| BECHTEL | **Mechanical Handling Data Sheet**<br>Top Running, Double Girder | CM 3 | Data Sheet No. 24590-HLW-M0D-HPH-00063<br>Plant Item No. 24590-HLW-MJ-HPH-CRN-00002 — Rev. 3 |

| Project | RPP-WTP | Description | Canister Handling Crane (Upper) |

| **Mechanical Handling Data Sheet**<br>Top Running, Double Girder | Data Sheet No.<br>24590-HLW-M0D-HPH-00063 | |

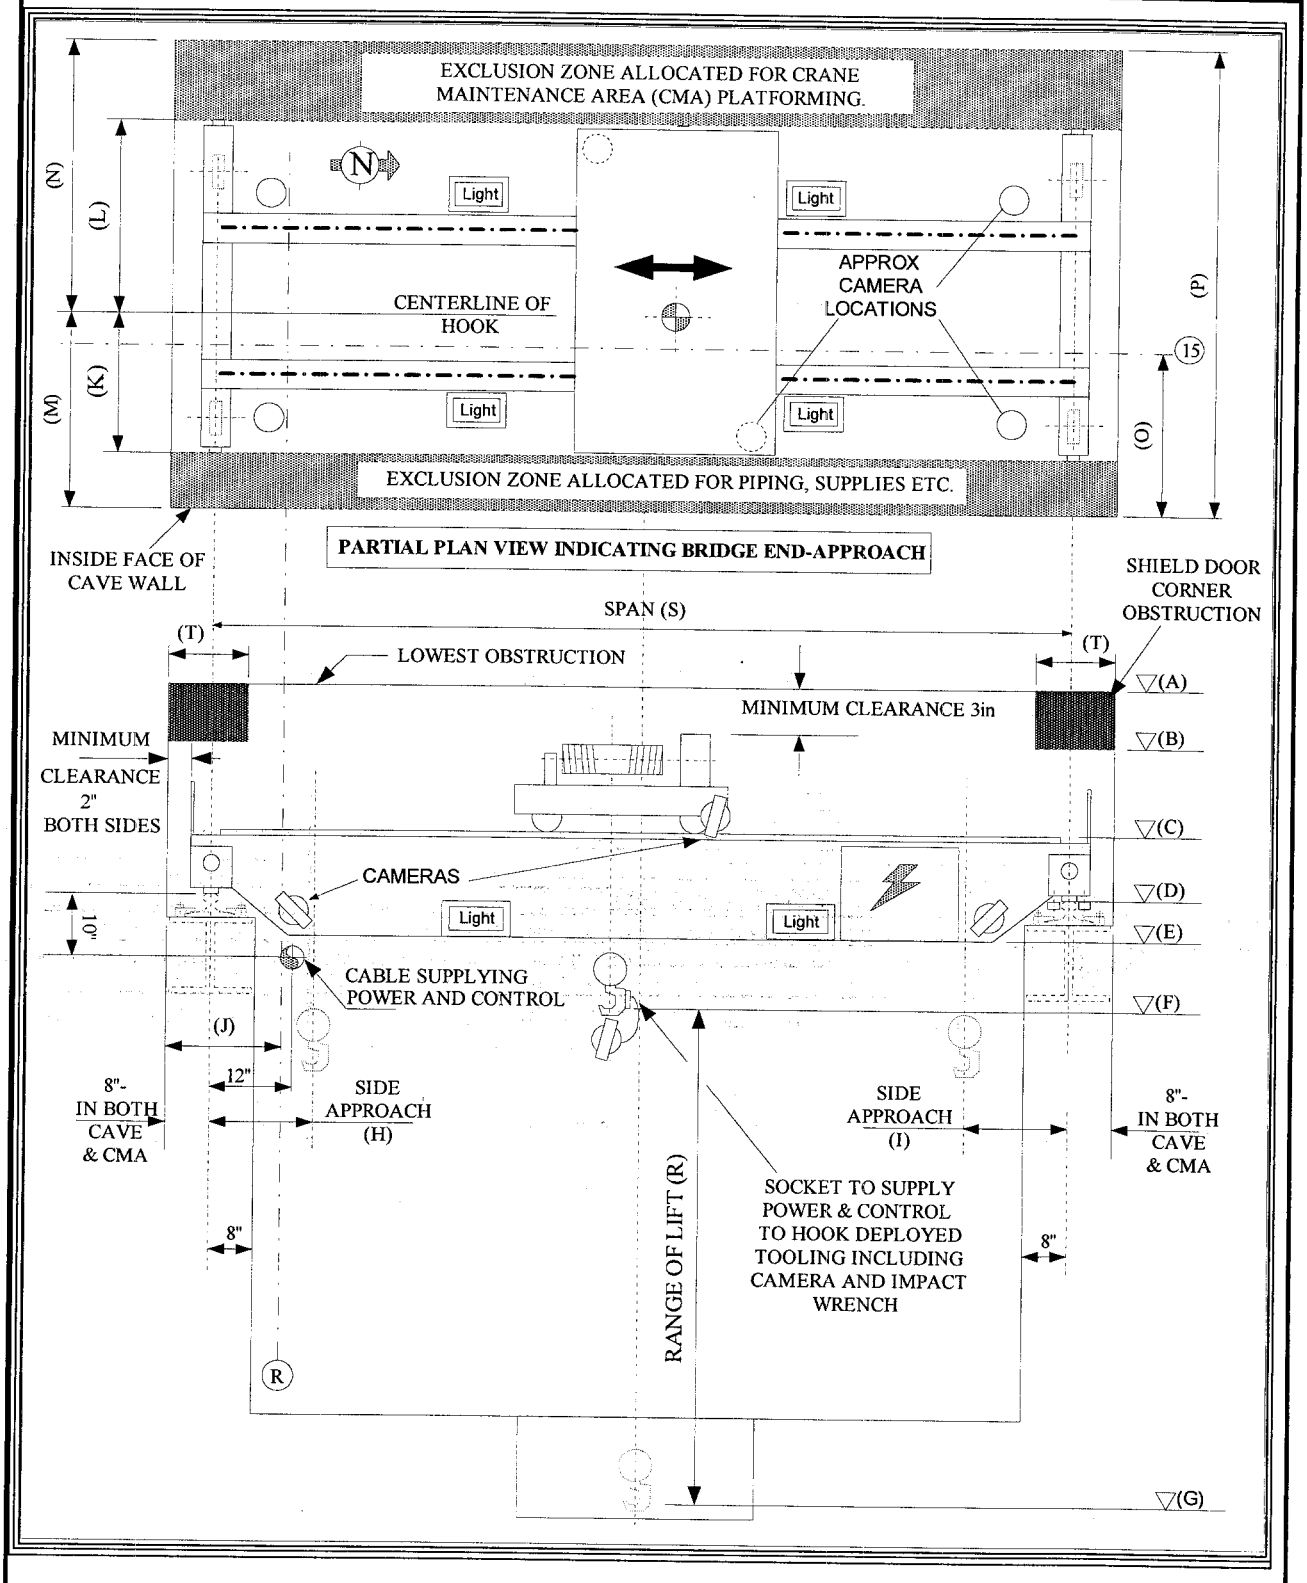
► 13. Revision 3 changes: Safety Classification changed to APC; Quality Level changed to CM; Calc ref deleted; Dimension K & M ammended to include bumper extensions that allow bumpers to engage on cave wall, IAW 24590-HLW-ACA-M-05-00031 3

| **CRANE DIMENSIONS AND ELEVATIONS** | Symbol | ft - in. |
|---|---|---|
| Distance from hoist center line to end-truck East bumper | (K) 3 | ▶5'-7" |
| Distance from hoist center line to In-Cave East Wall | (M) 3 | ▶5'-7" |
